CERTIFICATE OF APPROPRIATENESS

Property: 805 Franklin Street, Lots 3, 4, & 5, Block 16, SSBB Subdivision. The property is a vacant lot situated on a 15,002 square foot (150’ x 100’) corner lot.

Proposal: New Construction – Construct a new 150,000 square foot precast concrete 10-tier (plus ground level) parking garage on an existing vacant lot. The proposed parking garage will front Franklin and Milam Streets.

Recommendation: Deferral

SOUTH ELEVATION – FACING FRANKLIN STREET

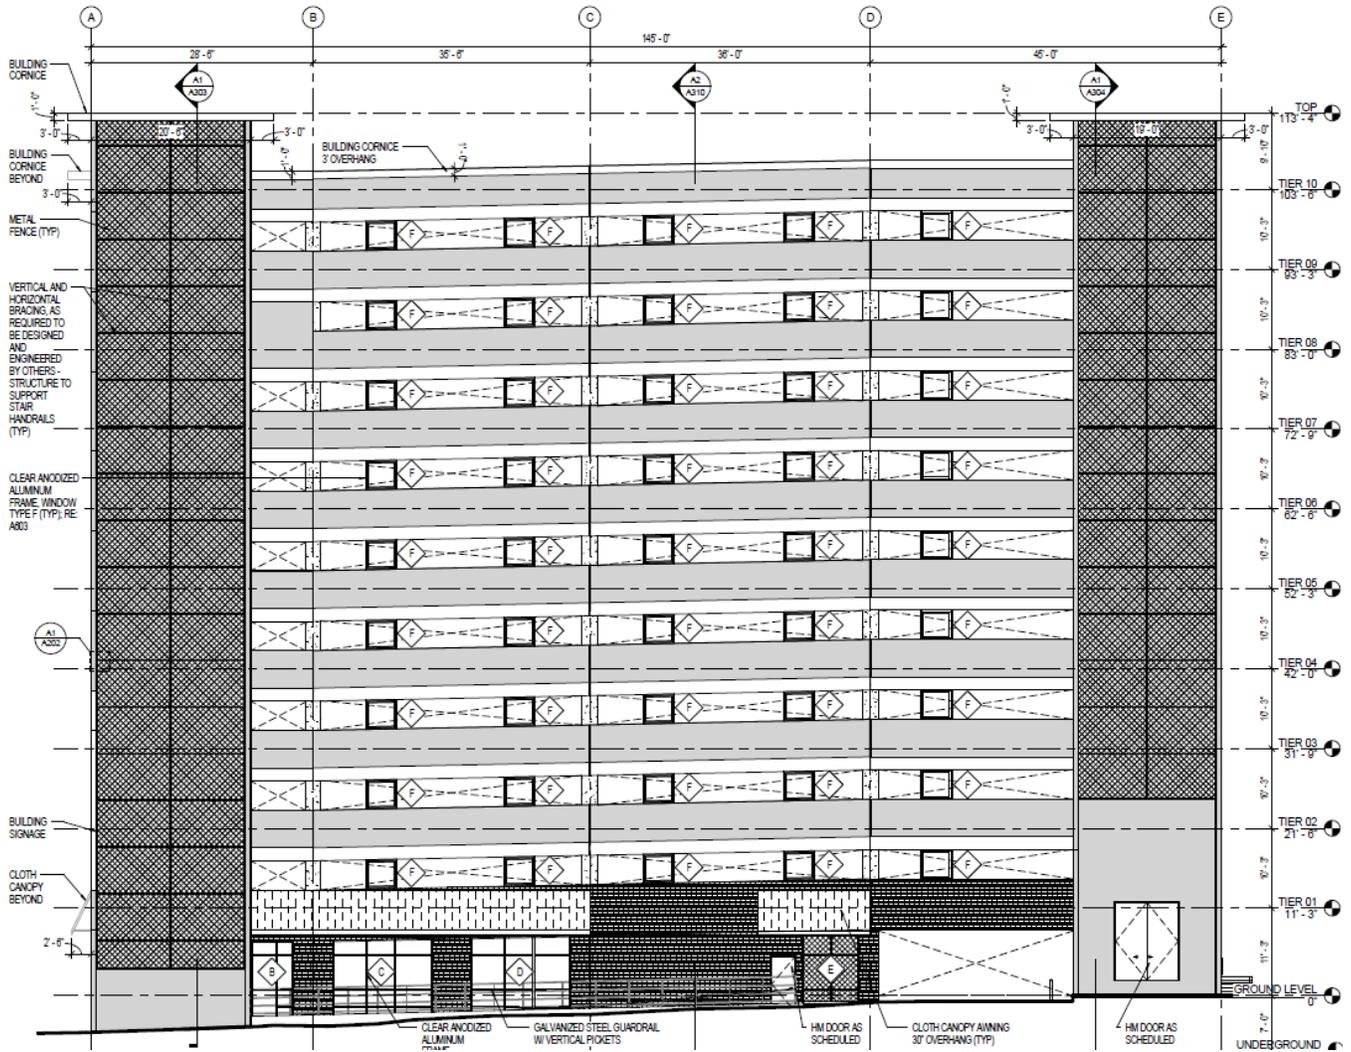
The applicant and staff have diligently worked together in order to design a compatible structure that compliments the existing historic buildings in the district. However, at this point, the exterior features of the proposed structure are not fully compatible with the exterior features of other contributing structures in the context area.

Despite being relatively tall, the massing, scale, and proportion of the structure appears to fit within the context area as the surrounding buildings are taller than the typical two-three stories seen in other parts of the district. The main issues of the project involve the horizontal nature of the structure as well as the street level detailing. Satisfying criteria can be accomplished by incorporating more vertical elements to better match vertical elements, such as window openings, that are typically found within the district. Although this can be partially seen on the Milam elevation with the inclusion of vertical aluminum window frames; the square frames and overall horizontal nature along the Franklin side is uncharacteristic of the district. At the ground level, suspended awnings as opposed to cloth awnings should be installed above the storefronts. This type of awning is more typically seen throughout the district, and is more historically appropriate. The use of additional brick veneer and perhaps some form of curtain wall may also make the structure more compatible with the Main Street Market Square Historic District.
